SUBJECT: PALISADES PLANT - CABLE AMPACITY ADJUSTMENT METHODOLOGY
 (TAC NO. MA3808)

**A Review of the Harshe/Black Diversity Based Ampacity
Method as Published and as Applied at the Palisades Nuclear Plant**

Figure 1: Schematic of the Harshe-Black cable mass thermal model for conduction heat transfer analysis with the layered cable sections.

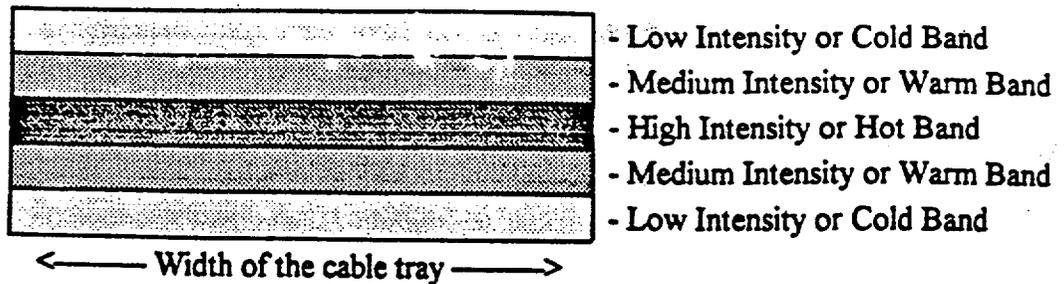
In contrast, the Harshe-Black method separates the cables in the tray into as many as three groups according to their actual in-service heat intensity loads; namely, the hot, warm, and cold (or high, medium, and low intensity) cable groups. A layered thermal conduction model is then assembled with the highest intensity cables in the center, and the lowest intensity cables at the top and bottom surfaces as illustrated in Figure 1. In the analysis it is clearly the high-intensity cable that are of primary concern. If these cables are operating at acceptable temperatures, then the other lower intensity cables will also be acceptable.

One other aspect of this change is also very important. That is, the heat generation rate for each layer is based on the sum of the actual heating rates for the individual cables in that group. This will substantially reduce the overall system heat load in comparison to the Stolpe model in which all cables are assumed to be powered to the code limit ampacity.

The Harshe-Black model is clearly less conservative than the Stolpe/ICEA model, a fact acknowledged by PNP. Indeed, it can result in substantially higher ampacity limits in comparison to the Stolpe assumptions. This is discussed in more detail in Appendix B below. Some of the inherent conservatisms associated with the Harshe-Black method are:

Figure B-1: Schematic representation of the TVA diversity test cable tray indicating the four cable power groups. Note that groups 1 and 4 were powered to some level in all tests.

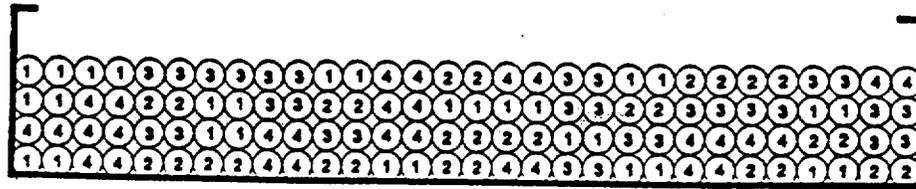
There are some inherent limitations to this data. The most significant is that there was no systematic attempt to locate the actual hot spots in the tray. This is because not all of the cables in the tray were instrumented. Rather, a large number of preselected cables were instrumented prior to installation, many of these cables concentrated around the center of the tray with a more limited selection of thermocouples at the edges of the tray. The cable groupings were then chosen at random after installation. Hence, the actual hot spot temperatures may not have been truly captured. This is somewhat mitigated by the fact that several of the group 1 and 4 cables are present in a cluster near the center of the tray, and many of these cables were, in fact, instrumented. Hence, it can be concluded that the measured temperatures did characterize at least one of the two highest power density regions in the tray. However, the data should be viewed as somewhat suspect with the actual hot-spots somewhat uncertain. None-the-less some indication of the model behavior for these cases can be discerned.

The reported test data includes the measured maximum cable temperature in each test. Given this data it is quite simple to simulate each test using the Harshe-Black methodology. In this case, the cables in each group represent one full layer of cables across the width of the tray. Hence, there will be no distinction between the base as-published method and the PNP modified method. Either would yield identical results.
